CITY OF  
TUCSON  
TUCSON WATER  
DEPARTMENT

## Tucson Water Standard Specifications and Details 2011 Edition – Engineering Directive 03-2014

Effective Date: January, 2014

**SUBJECT: Revise Standard Specifications – SD-1801,1802,1803,1804,1805,1806,1807,1808**

ISSUED:		<b>STANDARD DETAIL BACKFLOW PREVENTION POTABLE WATER FIRE HYDRANT OR STANDPIPE WATER SERVICE</b>		DETAIL NO.
8/00				SD-1801
REVISED:				SHEET 1 OF 1
10/13

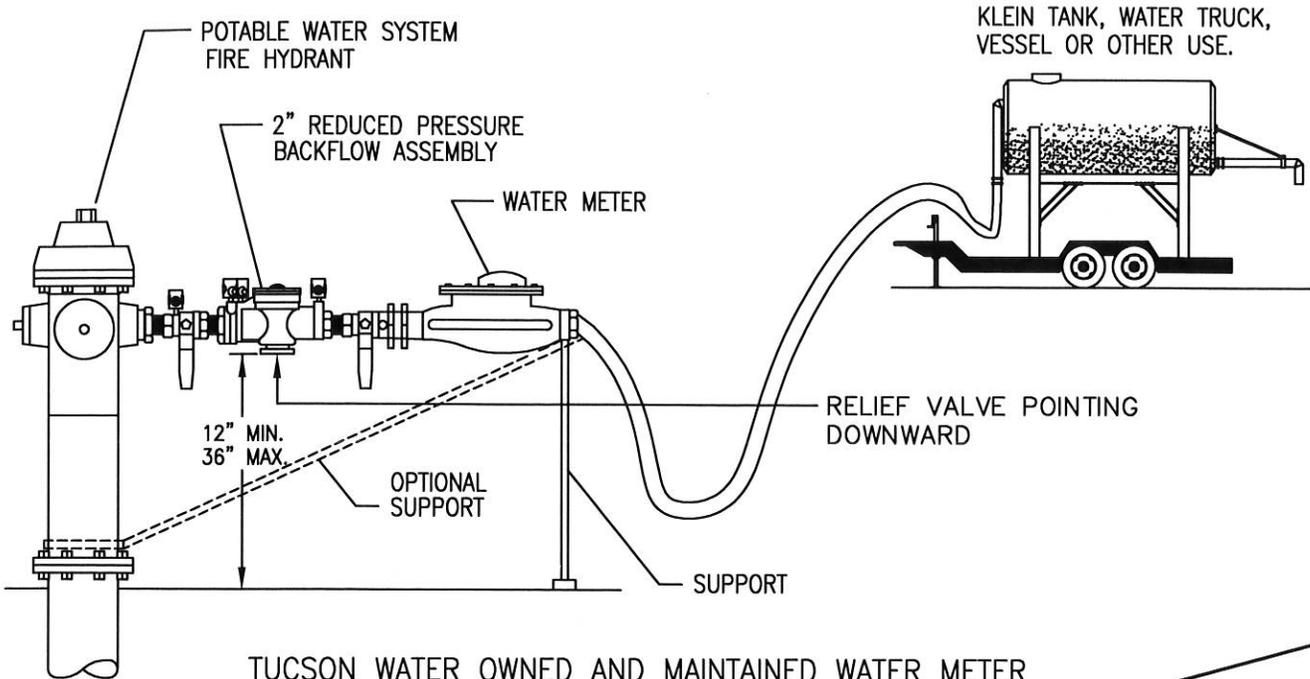
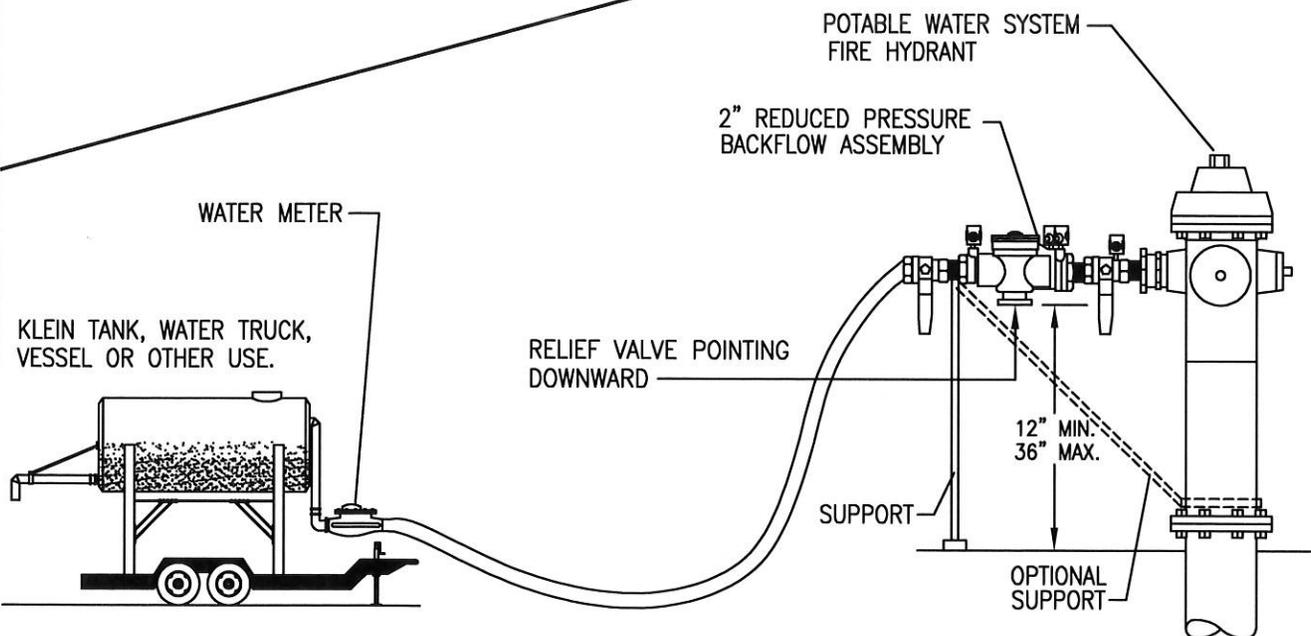
- **SD-1801 Backflow Prevention Potable Water Fire Hydrant or Standpipe Water Service.**  
Sheet 1 of 1, at the top of the page remove the text “Hydrant Mounted RP Backflow Assembly and Water Meter” and add the text “Tucson Water Owned and Maintained Water Meter with Tucson Water Owned and Maintained RP Backflow Assembly.” At the bottom of the page remove the text “Hydrant Mounted RP Backflow Assembly and Remote Meter” and add the text “Contractor Owned and Maintained Water Meter with Contractor Owned and Maintained RP Backflow Assembly.”

TUCSON WATER OWNED AND MAINTAINED WATER METER  
WITH TUCSON WATER OWNED AND MAINTAINED  
RP BACKFLOW ASSEMBLY

CONTRACTOR OWNED AND MAINTAINED WATER METER  
WITH CONTRACTOR OWNED AND MAINTAINED  
RP BACKFLOW ASSEMBLY

<b>ISSUED:</b>		<b>STANDARD DETAIL</b>		<b>DETAIL NO.</b>
12/97		<b>BACKFLOW PREVENTION</b>		<b>SD-1802</b>
<b>REVISED:</b>		<b>REDUCED PRESSURE</b>		<b>SHEET 1 OF 1</b>
10/13		<b>ASSEMBLY (RPA)</b>		
		<b>INSTALLATION</b>

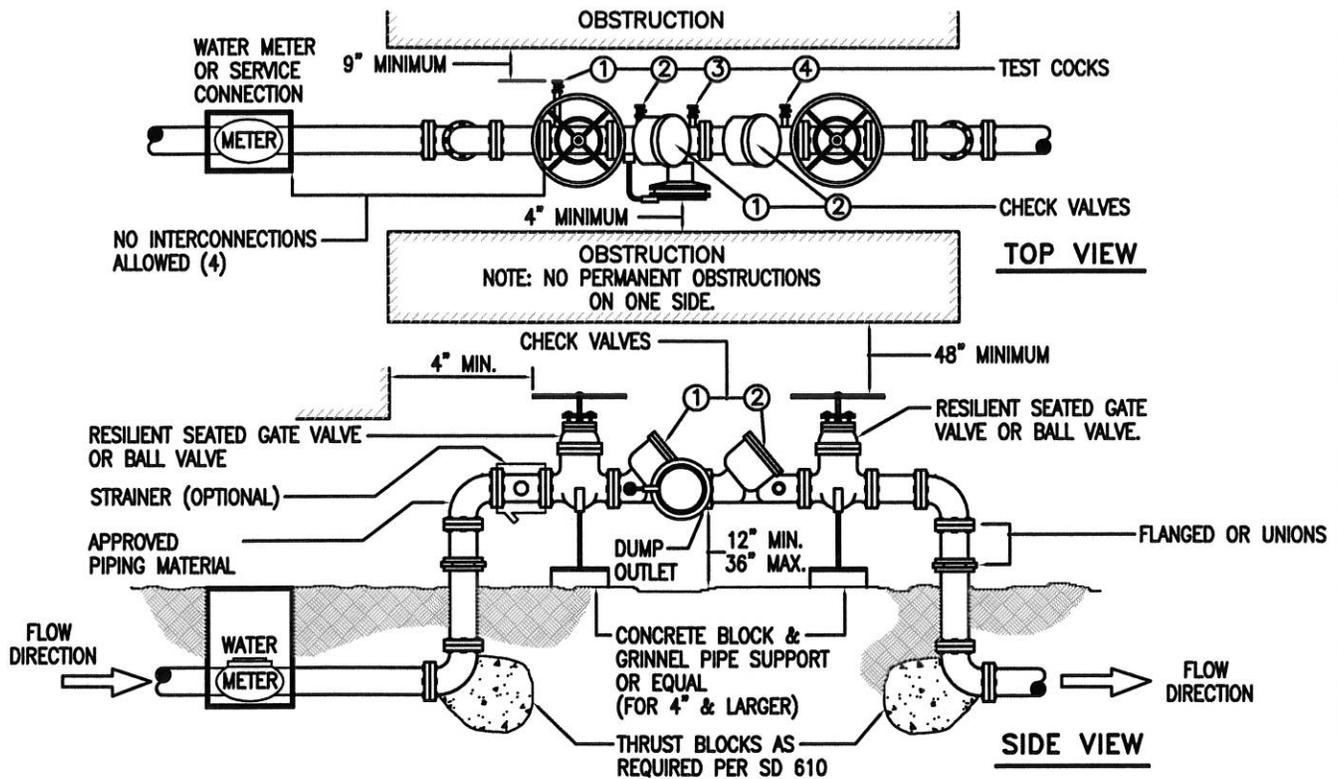
- **SD-1802 Backflow Prevention Reduced Pressure Assembly (RPA) Installation.**  
Sheet 1 of 1, remove notes 2, 3, 4, 5, 6, 7, 8, 9, and 10 and replace with the following notes:

2. A list of approved backflow assemblies is maintained by Tucson Water.
  3. For containment protection, the backflow assembly listed in this SD shall be installed outside, above ground, as close to the water meter or service connection as possible and on private property unless otherwise authorized.  
(right-of-ways are not private property)

4. There shall be no other piping connected to the piping between the water meter and the backflow assembly except for parallel installations.

5. Installations shall meet current plumbing codes and fire codes as applicable in addition to Tucson Water's Standard Details. (See #11 Approved piping materials)

6. Installations shall be left exposed until inspected and approved by Tucson Water.
  7. Protective cages are optional, and shall meet clearance, access and drainage requirements.

8. Backflow assemblies shall be protected from freezing. Care shall be taken to ensure that the protection does not hinder the operation of the assembly. Insulation shall not interfere with the operation of the test cocks, any dump port, shut off valves or identification name plate.

9. Before installing a backflow assembly on any fire system, consult with the fire authority for additional requirements.
  10. The installation of a backflow assembly may create a closed system. Consult local plumbing codes for pressure relief valve and thermal expansion requirements.

11. Approved piping materials shall be: Copper type L or K, Galvanized SCH 40, or Ductile Iron.
  12. For additional information contact the Backflow Prevention Section at (520) 791-2650.

<b>ISSUED:</b>		<b>STANDARD DETAIL</b>		<b>DETAIL NO.</b>
6/97		<b>BACKFLOW PREVENTION</b>		<b>SD-1803</b>
<b>REVISED:</b>		<b>PRESSURE VACUUM BREAKER</b>		
10/13		<b>ASSEMBLY (PVB)</b>		
		<b>INSTALLATION</b>	<b>SHEET 1 OF 1</b>

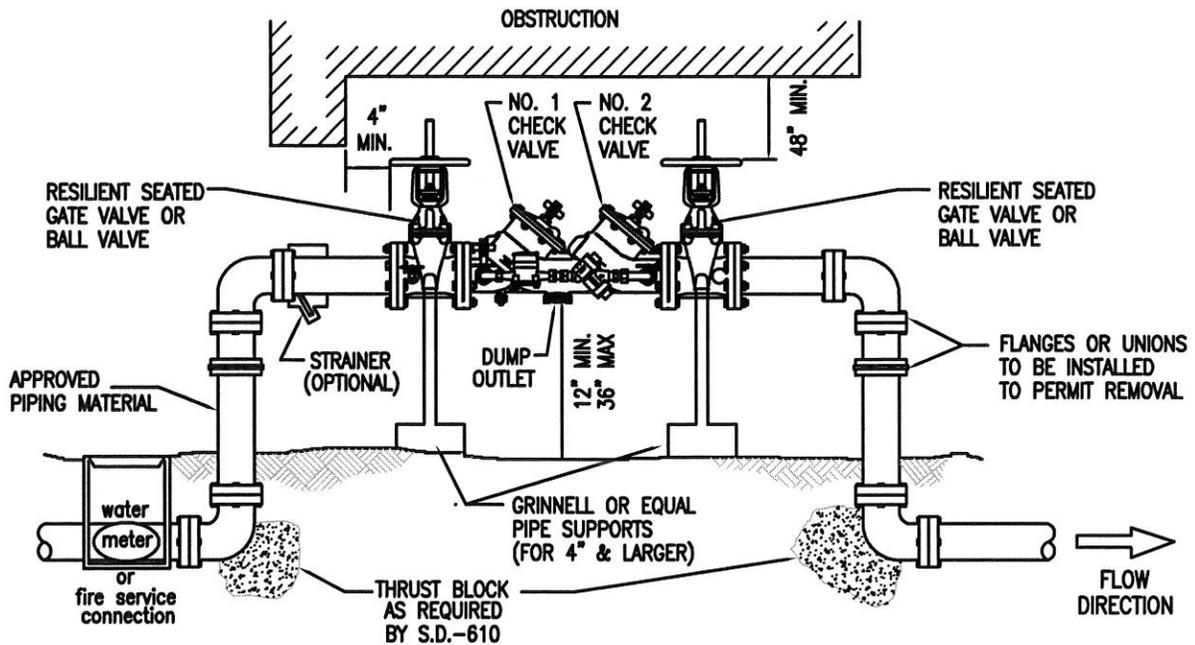
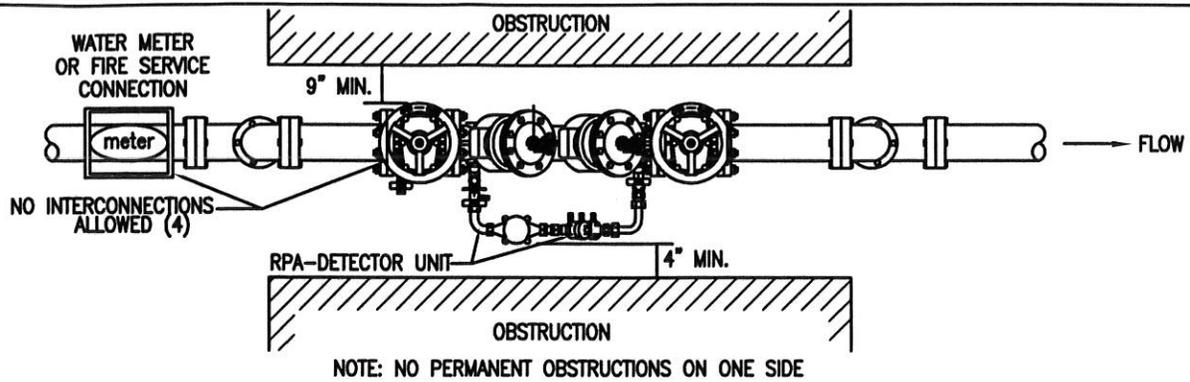
- **SD-1803 Backflow Prevention Pressure Vacuum Breaker Assembly (PVB) Installation.**  
Sheet 1 of 1, remove notes 2, 3, 4, 5, 6, 7, 8, 9, and 10 and replace with the following notes:

2. A list of approved backflow assemblies is maintained by Tucson Water.
    3. For containment protection, the backflow assembly listed in this SD shall be installed outside, above ground, as close to the water meter or service connection as possible and on private property unless otherwise authorized. (right-of-ways are not private property)

4. There shall be no other piping connected to the piping between the water meter and the backflow assembly except for parallel installations.
    5. Installations shall meet current plumbing codes and fire codes as applicable in addition to Tucson Water's Standard Details. (See #11 Approved piping materials)

6. Installations shall be left exposed until inspected and approved by Tucson Water.
    7. Protective cages are optional, and shall meet clearance, access and drainage requirements.

8. Backflow assemblies shall be protected from freezing. Care shall be taken to ensure that the protection does not hinder the operation of the assembly. Insulation shall not interfere with the operation of the test cocks, any dump port, shut off valves or identification name plate.

9. Before installing a backflow assembly on any fire system, consult with the fire authority for additional requirements.
    10. The installation of a backflow assembly may create a closed system. Consult local plumbing codes for pressure relief valve and thermal expansion requirements.

11. Approved piping materials shall be: Copper type L or K, Galvanized SCH 40, or Ductile Iron.
    12. For additional information contact the Backflow Prevention Section at (520) 791-2650.

ISSUED:		<b>STANDARD DETAIL</b>		DETAIL NO.
9/04		<b>BACKFLOW PREVENTION</b>		SD-1804
REVISED:		<b>REDUCED PRESSURE</b>		
10/13		<b>DETECTOR ASSEMBLY (RPDA)</b>		<b>INSTALLATION</b>

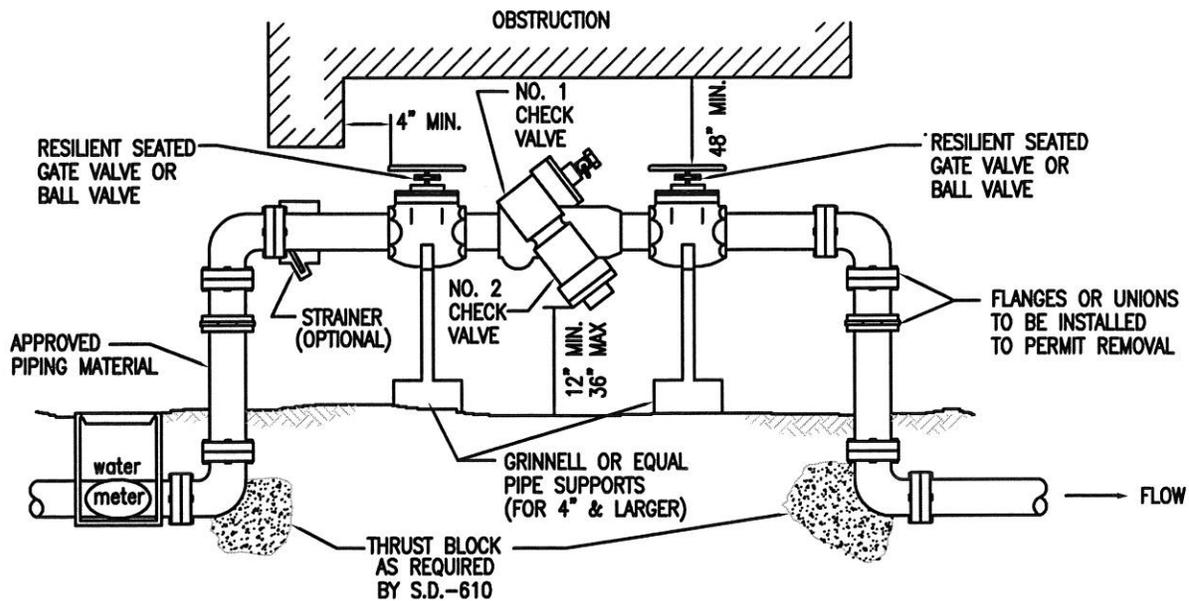
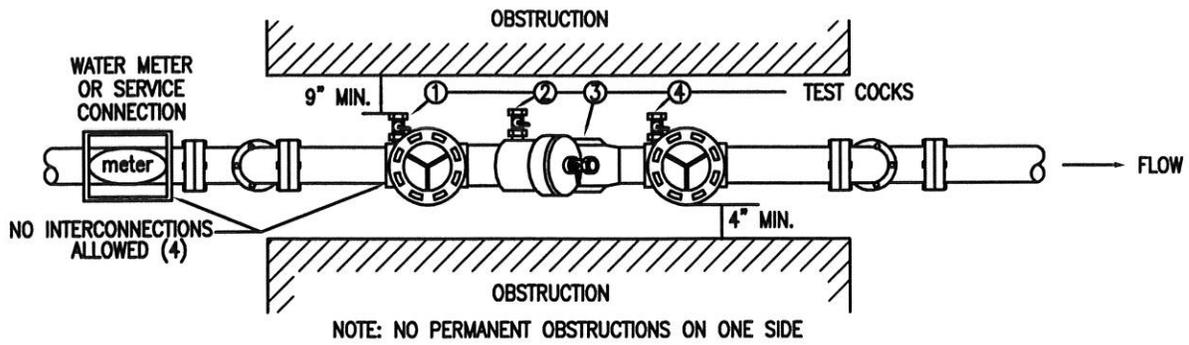
- **SD-1804 Backflow Prevention Reduced Pressure Detector Assembly (RPDA) Installation.**

Sheet 1 of 1, remove notes 2, 3, 4, 5, 6, 7, 8, 9, and 10 and replace with the following notes:

2. A list of approved backflow assemblies is maintained by Tucson Water.
3. For containment protection, the backflow assembly listed in this SD shall be installed outside, above ground, as close to the water meter or service connection as possible and on private property unless otherwise authorized. (right-of-ways are not private property)

4. There shall be no other piping connected to the piping between the water meter and the backflow assembly except for parallel installations.
5. Installations shall meet current plumbing codes and fire codes as applicable in addition to Tucson Water's Standard Details. (See #11 Approved piping materials)

6. Installations shall be left exposed until inspected and approved by Tucson Water.
7. Protective cages are optional, and shall meet clearance, access and drainage requirements.

8. Backflow assemblies shall be protected from freezing. Care shall be taken to ensure that the protection does not hinder the operation of the assembly. Insulation shall not interfere with the operation of the test cocks, any dump port, shut off valves or identification name plate.

9. Before installing a backflow assembly on any fire system, consult with the fire authority for additional requirements.
10. The installation of a backflow assembly may create a closed system. Consult local plumbing codes for pressure relief valve and thermal expansion requirements.

11. Approved piping materials shall be: Copper type L or K, Galvanized SCH 40, or Ductile Iron.
12. For additional information contact the Backflow Prevention Section at (520) 791-2650.

<b>ISSUED:</b>		<b>STANDARD DETAIL BACKFLOW PREVENTION DOUBLE CHECK VALVE ASSEMBLY (DCVA) INSTALLATION</b>		<b>DETAIL NO.</b>
6/97				SD-1805
<b>REVISED:</b>				<b>SHEET 1 OF 1</b>
10/13

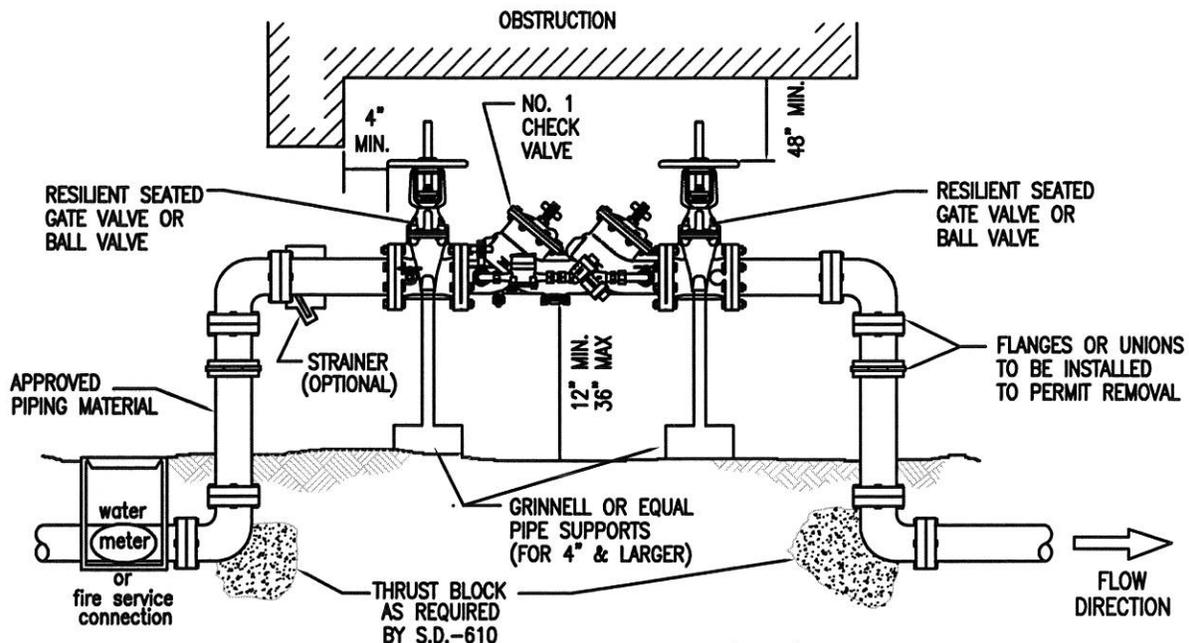
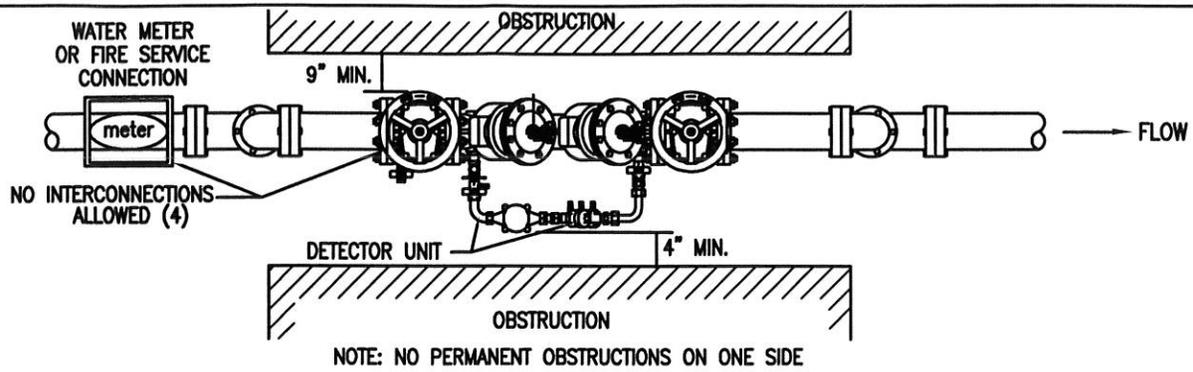
- **SD-1805 Backflow Prevention Double Check Valve Assembly (DCVA) Installation.**  
Sheet 1 of 1, remove notes 2, 3, 4, 5, 6, 7, 8, 9, and 10 and replace with the following notes:

2. A list of approved backflow assemblies is maintained by Tucson Water.
3. For containment protection, the backflow assembly listed in this SD shall be installed outside, above ground, as close to the water meter or service connection as possible and on private property unless otherwise authorized. (right-of-ways are not private property)
4. There shall be no other piping connected to the piping between the water meter and the backflow assembly except for parallel installations.
5. Installations shall meet current plumbing codes and fire codes as applicable in addition to Tucson Water's Standard Details. (See #11 Approved piping materials)
6. Installations shall be left exposed until inspected and approved by Tucson Water.
7. Protective cages are optional, and shall meet clearance, access and drainage requirements.

8. Backflow assemblies shall be protected from freezing. Care shall be taken to ensure that the protection does not hinder the operation of the assembly. Insulation shall not interfere with the operation of the test cocks, any dump port, shut off valves or identification name plate.
9. Before installing a backflow assembly on any fire system, consult with the fire authority for additional requirements.
10. The installation of a backflow assembly may create a closed system. Consult local plumbing codes for pressure relief valve and thermal expansion requirements.
11. Approved piping materials shall be: Copper type L or K, Galvanized SCH 40, or Ductile Iron.
12. For additional information contact the Backflow Prevention Section at (520) 791-2650.

<b>ISSUED:</b>		<b>STANDARD DETAIL BACKFLOW PREVENTION DOUBLE CHECK DETECTOR ASSEMBLY (DCDA) INSTALLATION</b>		<b>DETAIL NO.</b>
8/02				<b>SD-1806</b>
<b>REVISED:</b>		10/13

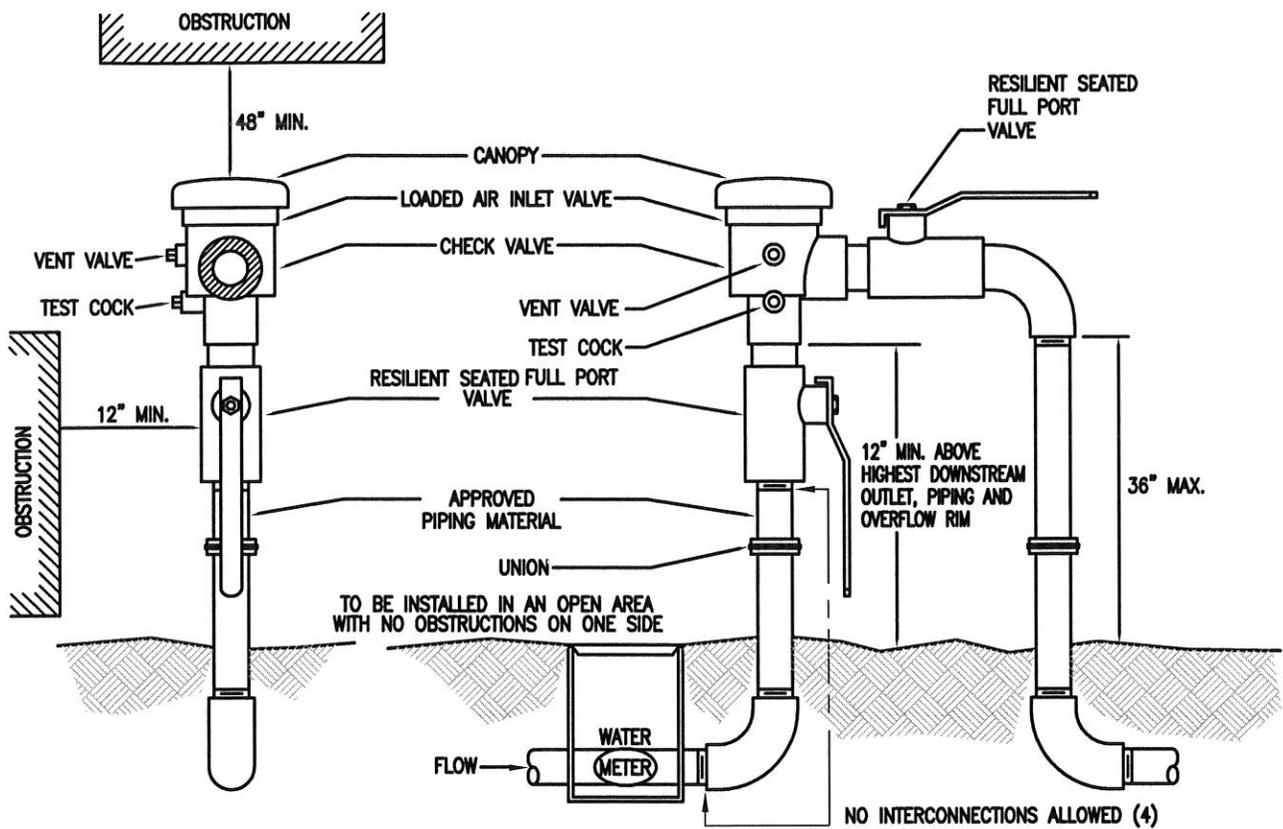
- **SD-1806 Backflow Prevention Double Check Detector Assembly (DCDA) Installation.**

Sheet 1 of 1, remove notes 2, 3, 4, 5, 6, 7, 8, 9, and 10 and replace with the following notes:

2. A list of approved backflow assemblies is maintained by Tucson Water.
3. For containment protection, the backflow assembly listed in this SD shall be installed outside, above ground, as close to the water meter or service connection as possible and on private property unless otherwise authorized. (right-of-ways are not private property)

4. There shall be no other piping connected to the piping between the water meter and the backflow assembly except for parallel installations.
5. Installations shall meet current plumbing codes and fire codes as applicable in addition to Tucson Water's Standard Details. (See #11 Approved piping materials)

6. Installations shall be left exposed until inspected and approved by Tucson Water.
7. Protective cages are optional, and shall meet clearance, access and drainage requirements.

8. Backflow assemblies shall be protected from freezing. Care shall be taken to ensure that the protection does not hinder the operation of the assembly. Insulation shall not interfere with the operation of the test cocks, any dump port, shut off valves or identification name plate.

9. Before installing a backflow assembly on any fire system, consult with the fire authority for additional requirements.
10. The installation of a backflow assembly may create a closed system. Consult local plumbing codes for pressure relief valve and thermal expansion requirements.

11. Approved piping materials shall be: Copper type L or K, Galvanized SCH 40, or Ductile Iron.
12. For additional information contact the Backflow Prevention Section at (520) 791-2650.
